Subject: Minutes for 60th Protection Sub-Committee Meeting.

60th Protection Sub-Committee Meeting (26th May, 2025)-MoM

Minutes of
60th Meeting of Protection Sub-Committee (PSC) of
Northern Regional Power Committee

Date and time of meeting : 26.05.2025 10.30 Hrs.

DR of 220 KV Kanpur(PG) (end)-Unchahar(NT) (PG) Ckt-1

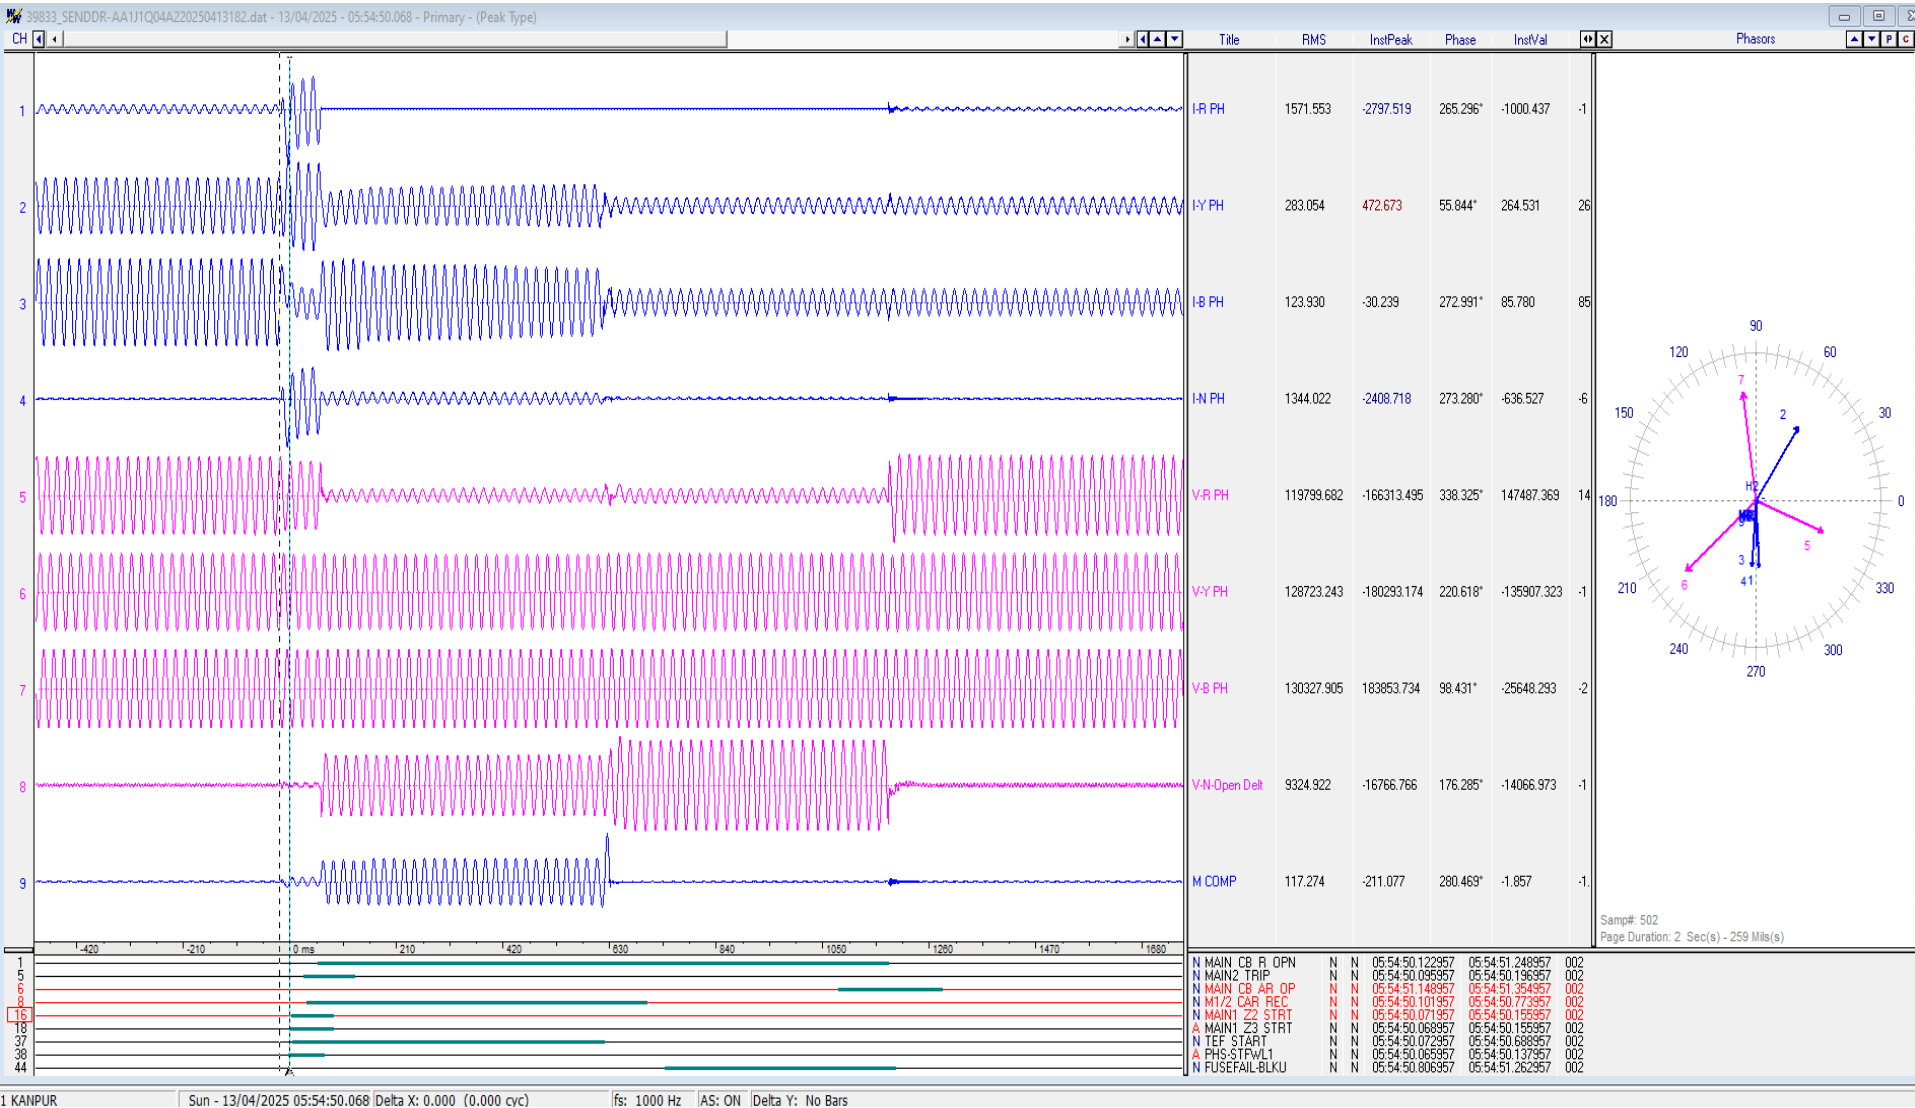
- ✓ R-N Phase to earth fault; $I_r \approx 1.57\text{kA}$
- ✓ Fault sensed in zone-2; carrier received
- ✓ A/R operated at Kanpur end; Line didn't trip from Kanpur end

DR of 220 KV Kanpur(PG) (end)-Unchahar(NT) (PG) Ckt-2

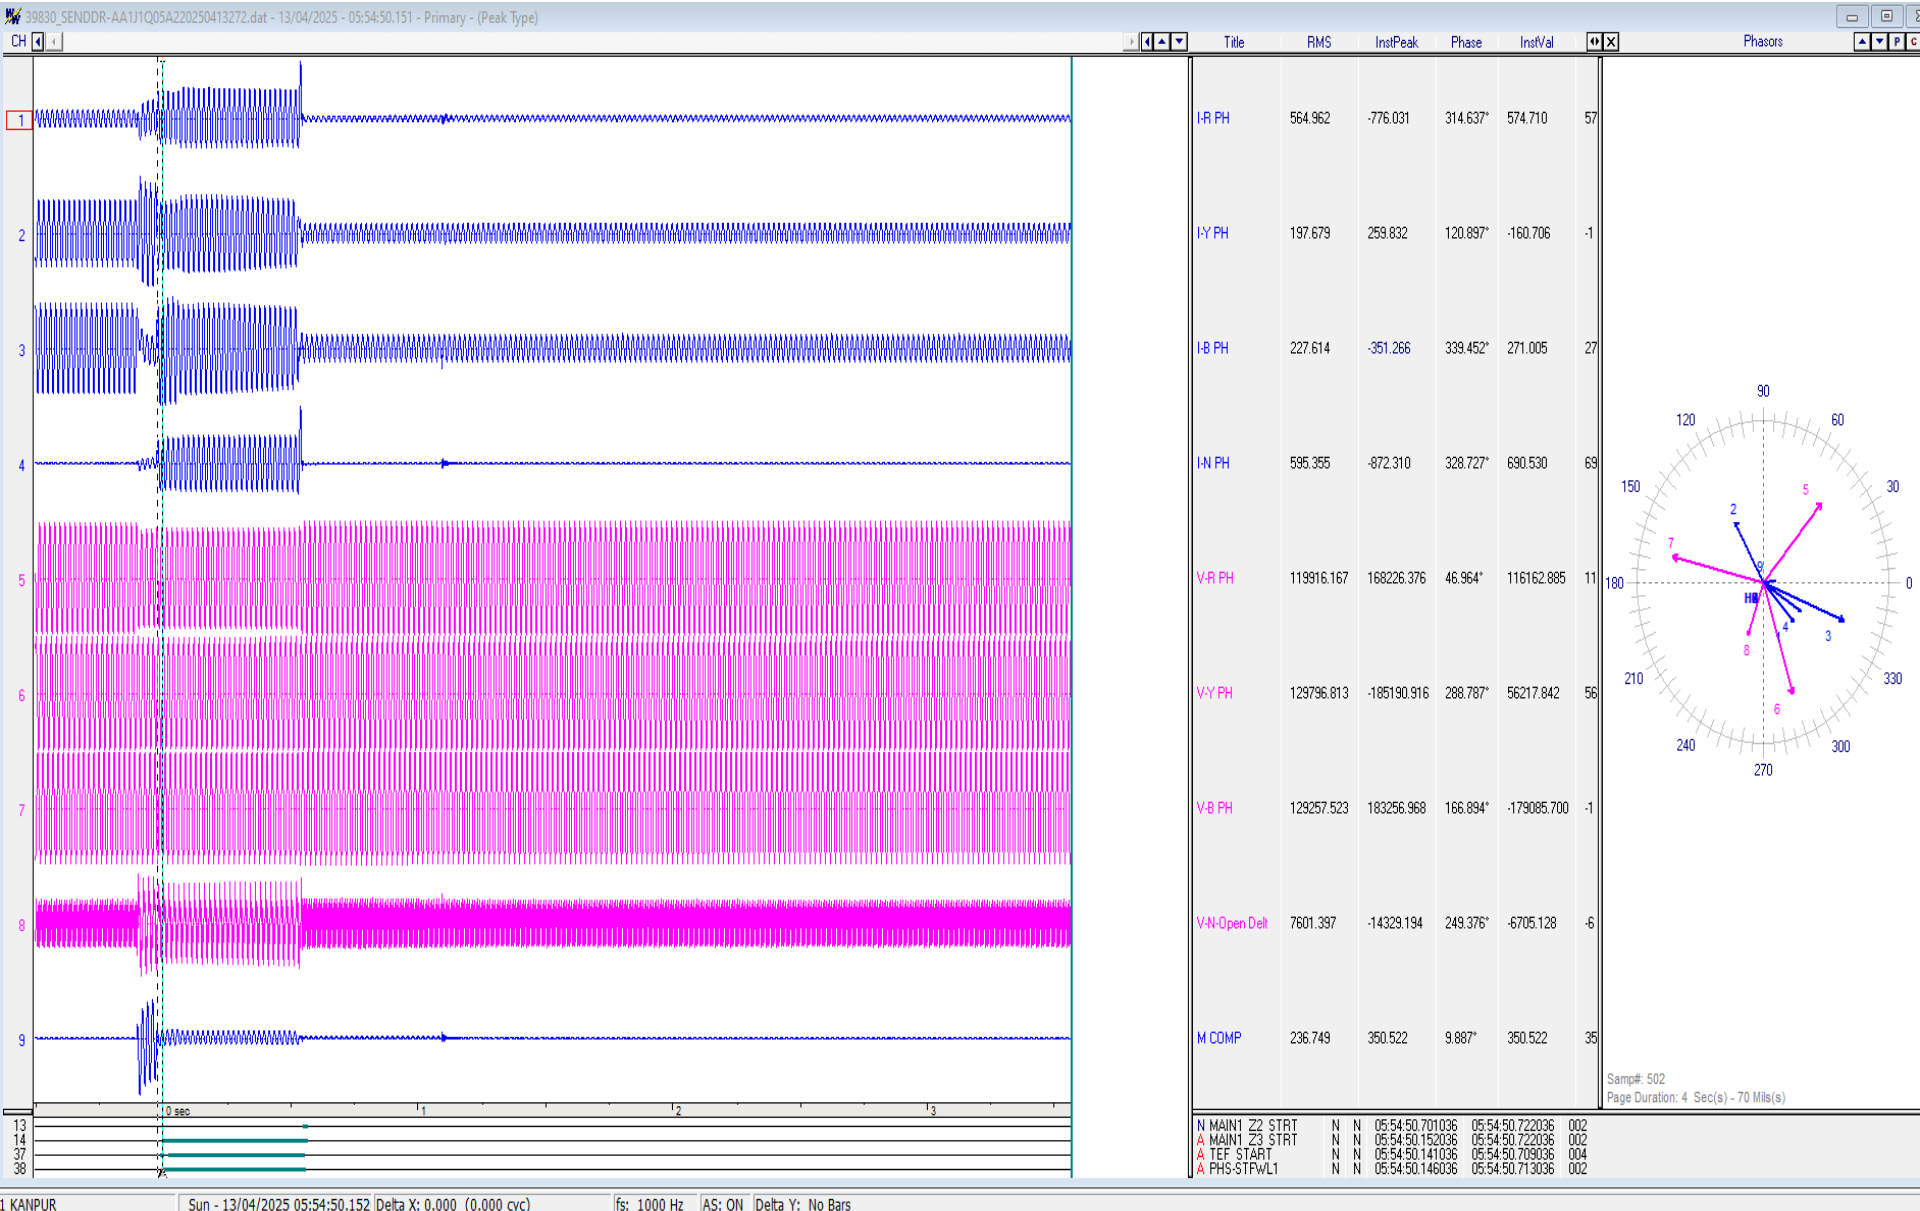
✓ Fault sensed in zone-2; Line didn't trip from Kanpur end

DR of 220 KV Unchahar(NT)-Raebareilly(PG) (end) (PG) Ckt-3

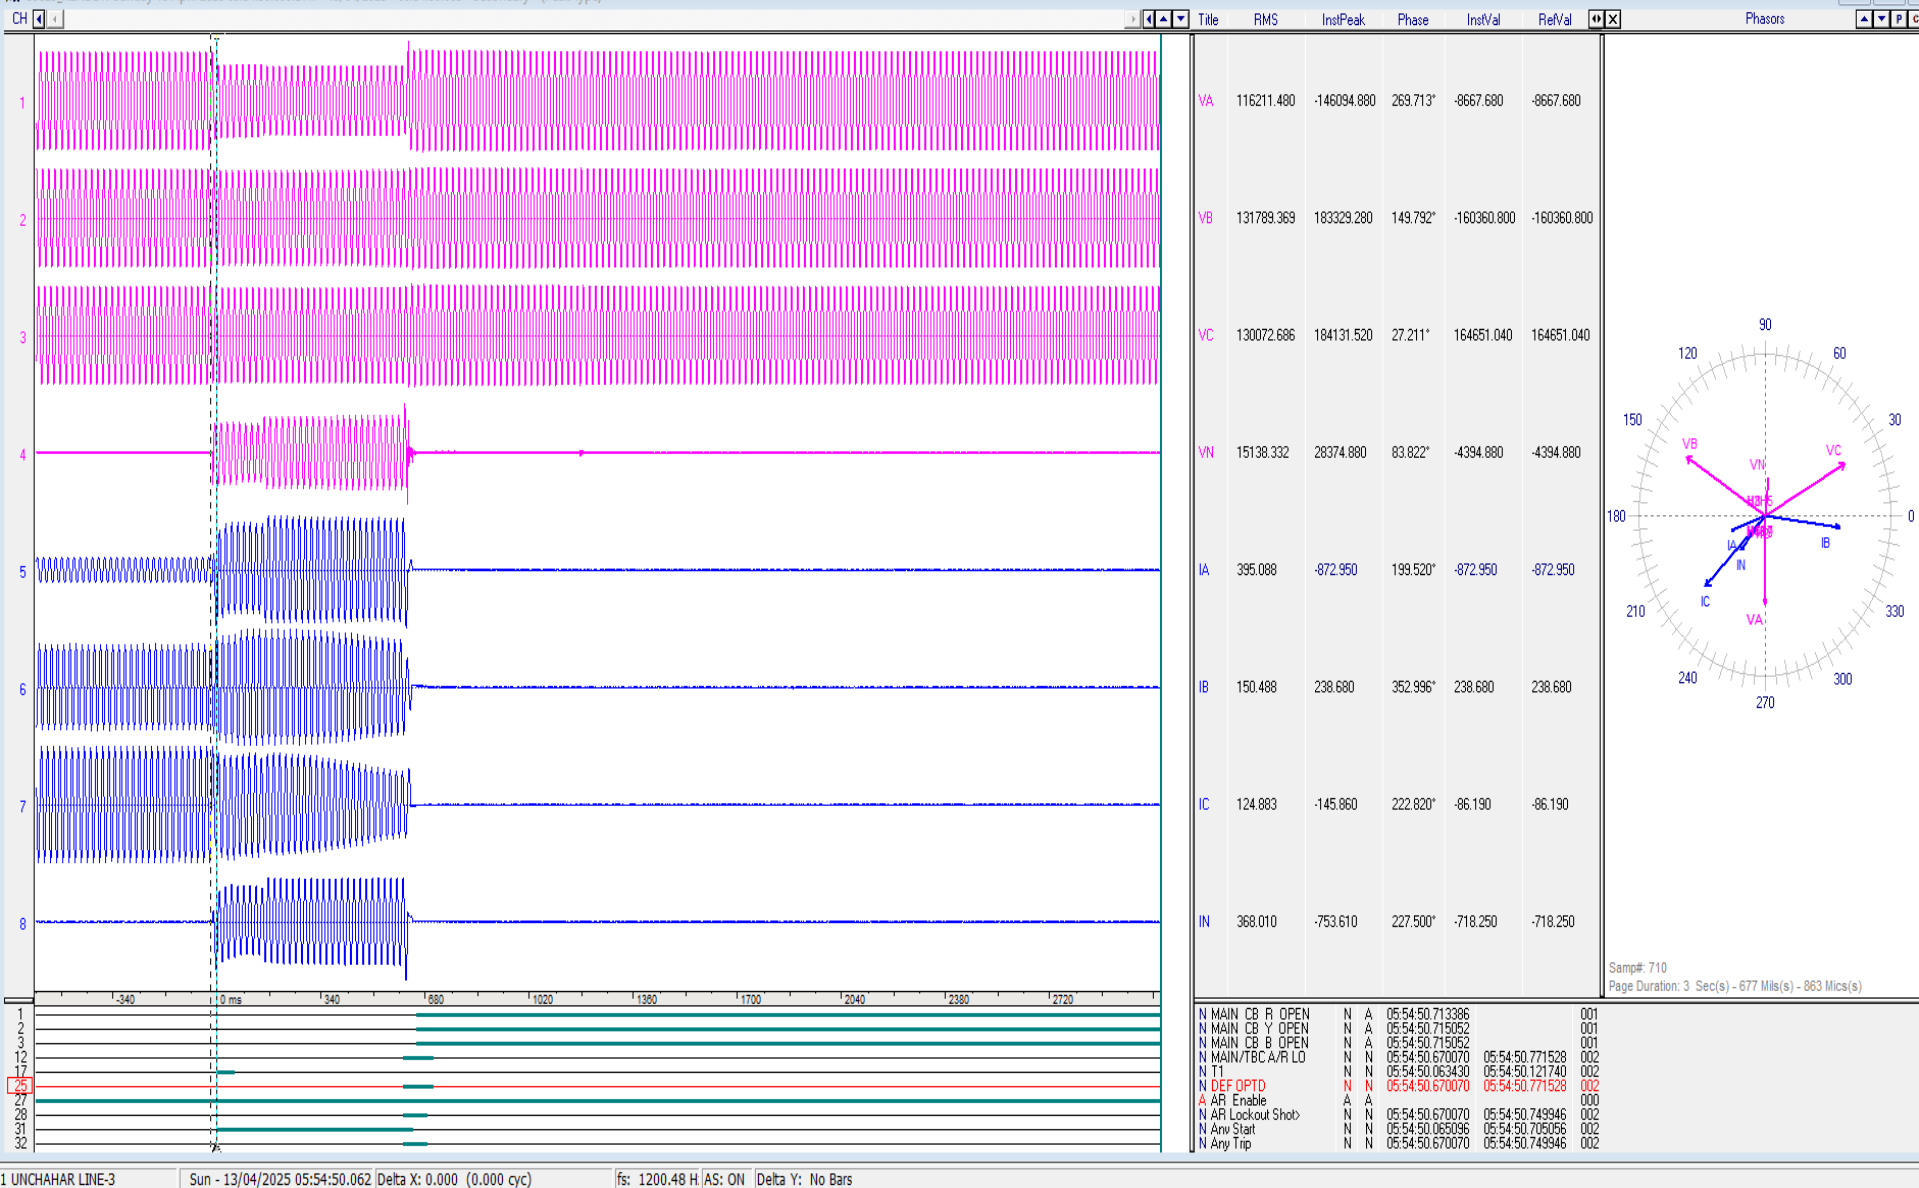
✓ Directional Earth Fault (DEF) operated at Raebareilly(PG)

DR of 400/220 kV 315 MVA ICT 1 at Gurgaon(PG)

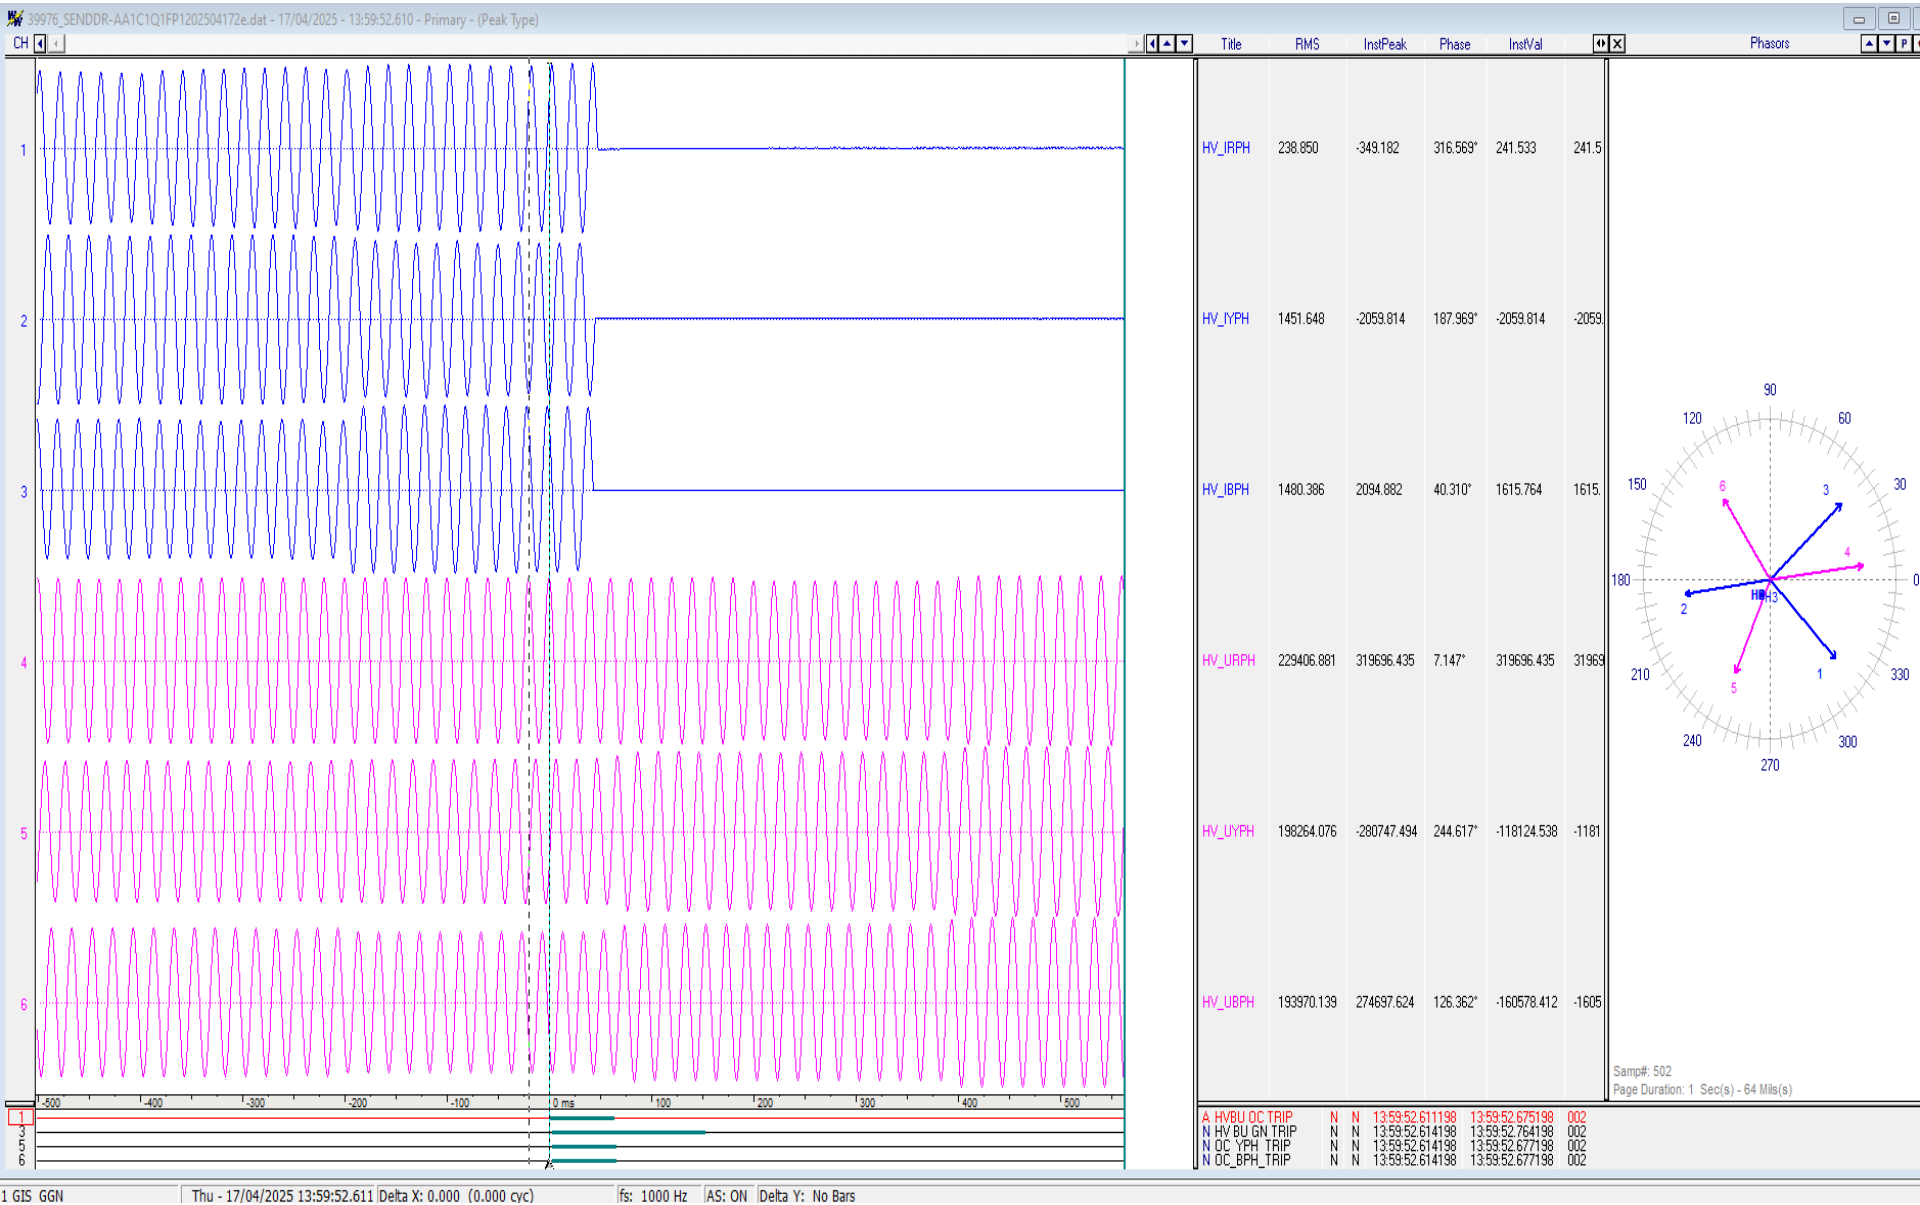
✓ HV side Back-up Over-current protection operated

DR of 400/220 kV 315 MVA ICT 2 at Gurgaon(PG)

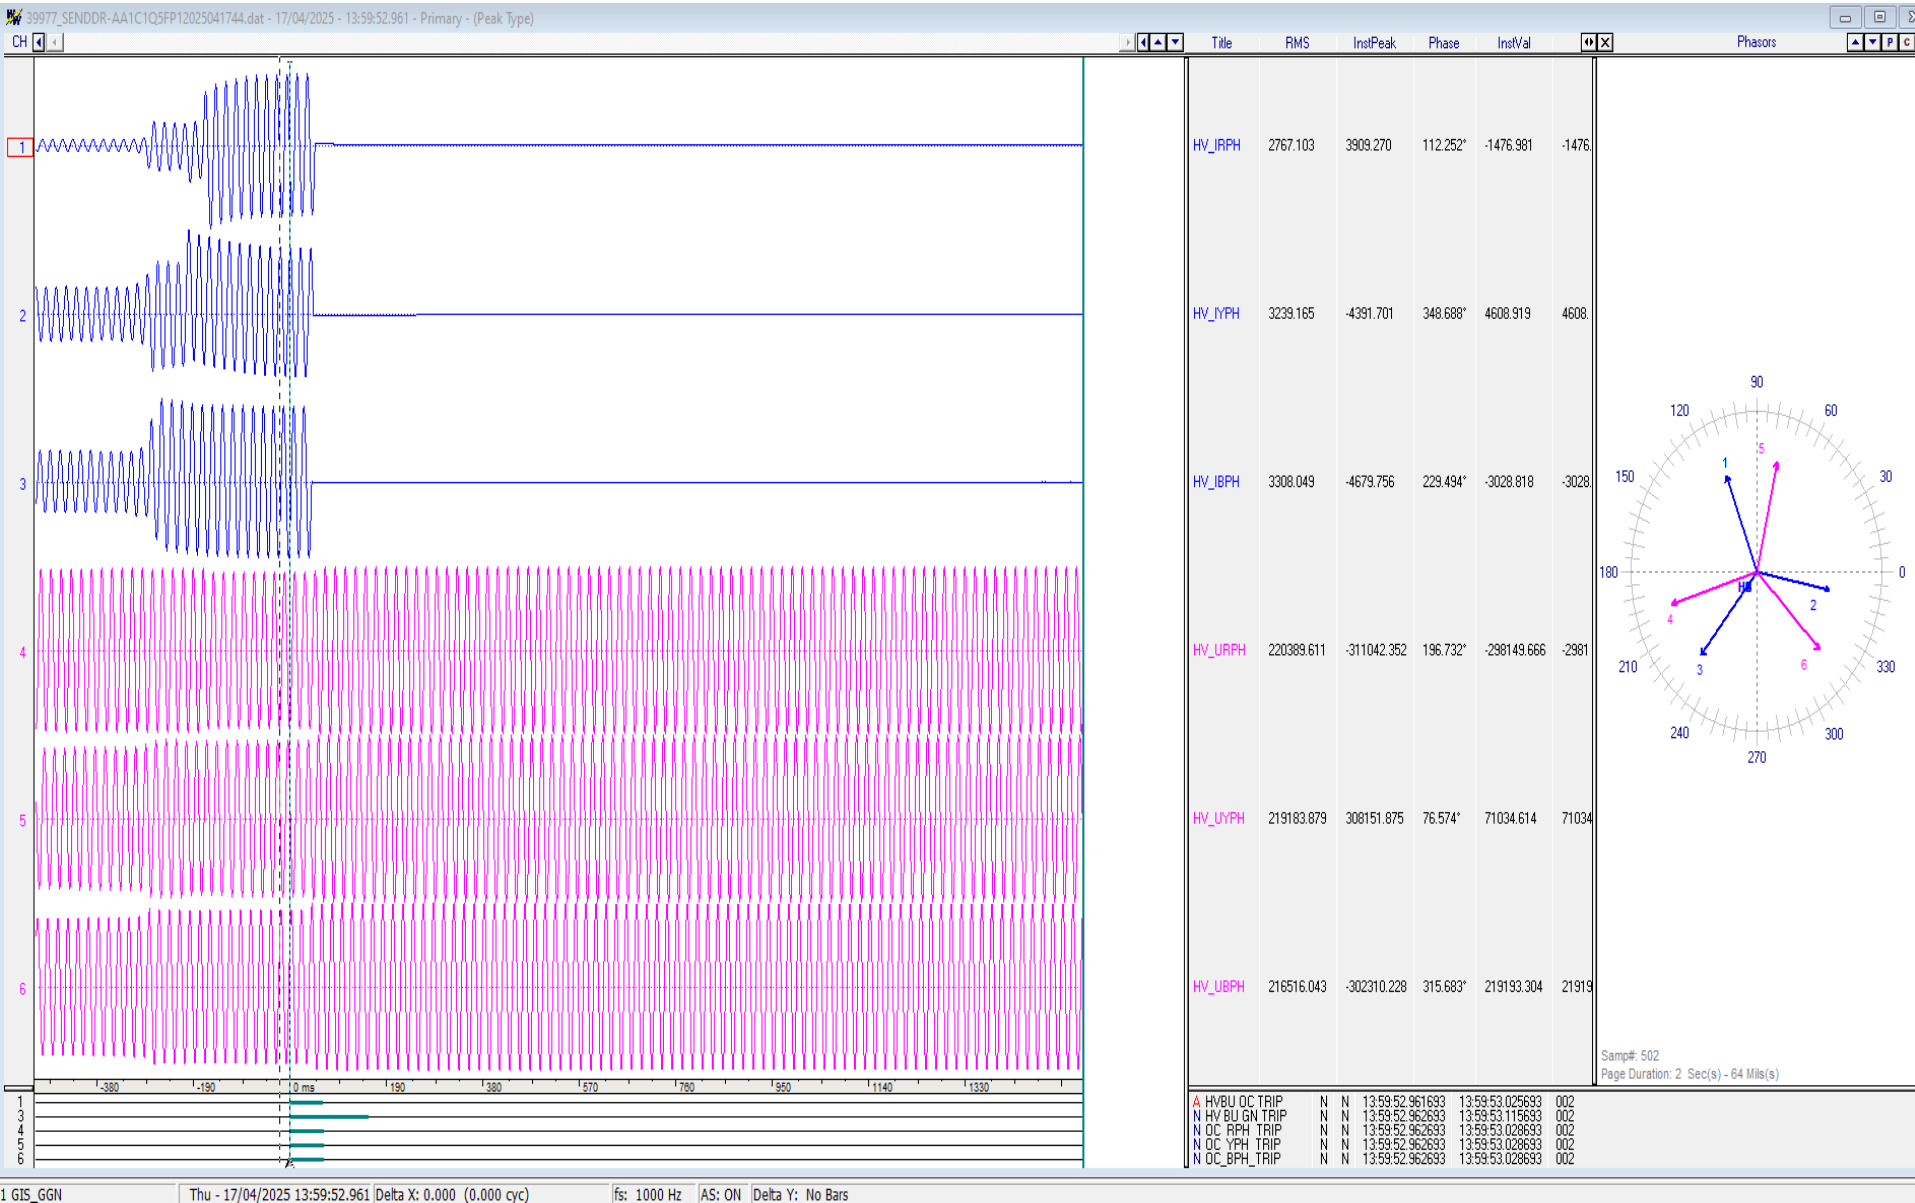
✓ HV side Back-up Over-current protection operated
